WATERWAYS ADVISORY COMMISSION

Oct. 12, 2014

Presently, we have evaluated the following two reports on the matter:

1. "Barnegat Bay Storm Surge Elevations During Hurricane Sandy And Sources Of Flooding Within The Bay" Prepared by The Richard Stockton College of New Jersey.
2. "Island Beach State Park Breach Analysis" Prepared by Stevens Institute of Technology.

Figure 3

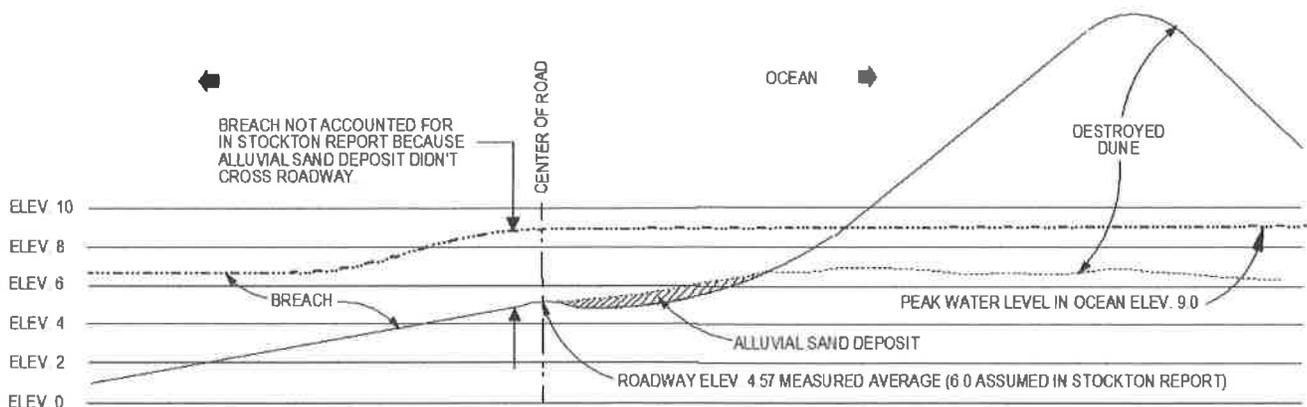
This analysis disagrees with the cross sectional area used in the Stockton report, as we have outlined previously. This analysis also disagrees with the 4 breach site figure as this analysis has documented 13 breach sites as detailed in the following pages. The cross sectional area shown in **Figure 3** below displays a typical type of breach that was not accounted for in the Stockton report because the alluvial sand deposit didn’t cross the roadway:

Figure 5: Graph shown on page 17 of Stevens report

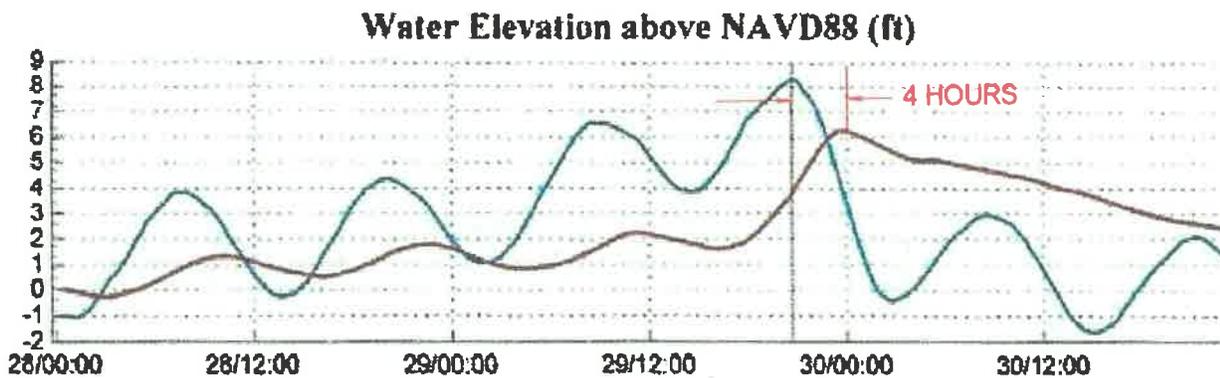
The Stevens report indicates that there was a 4 hour differential between the peak water levels in ocean and the peak water levels in the bay at IBSP. This is indicated by their following graph:

This analysis notes that the above graph is not based on real time measured tide data. It is based solely on their simulated computer modeling. It shows once the water levels reach its peak it rapidly declines. Actual real-time tide gauge measurements disclose that was not the case. **Figure 6** shows a sustained water level for the peaks lasting over 2 hours. In such a case there wouldn't be 4 hours between peaks as shown on the Stevens report. They would almost overlap.

Figure 6: Actual Tide Guage readings at the Mathis Bridge during Superstorm Sandy

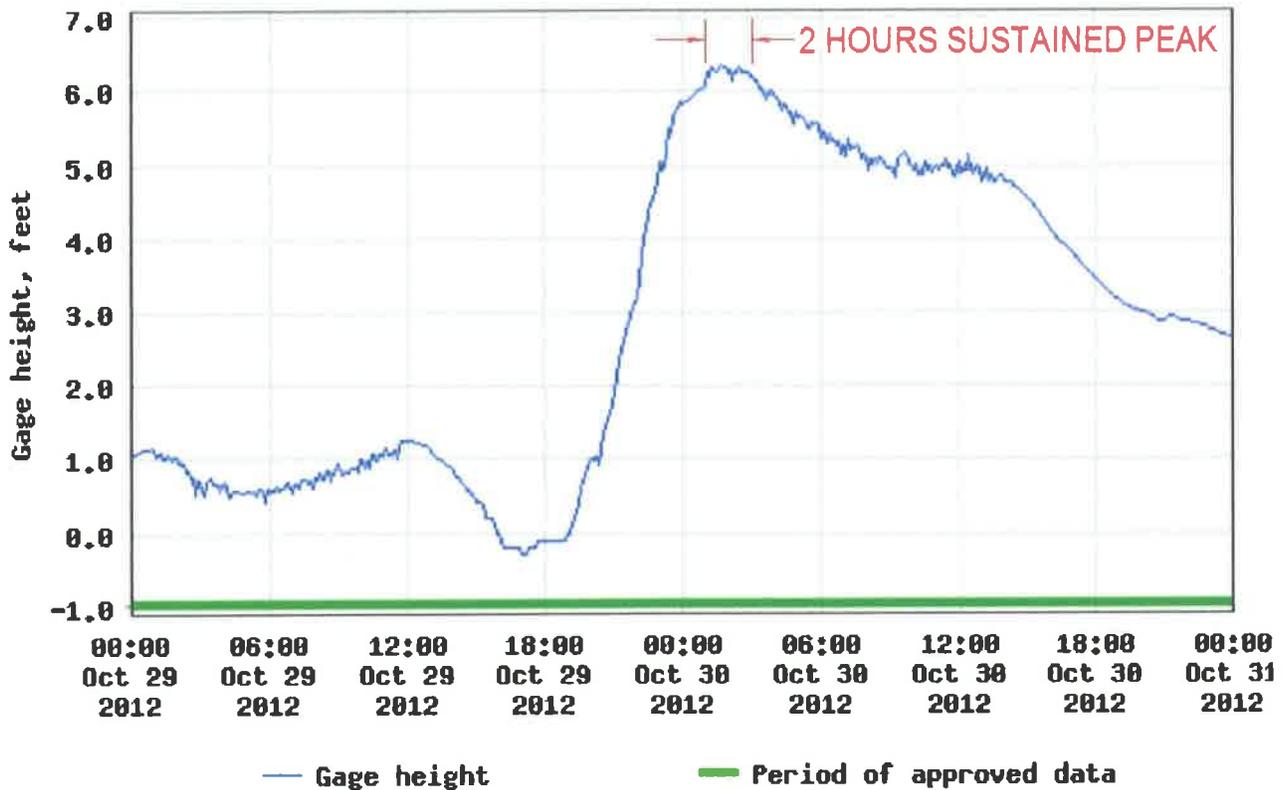
Figure 6 above shows a sustained water level during the storm peak not a rapid decline as the theoretical modeling indicates in the Stevens report.
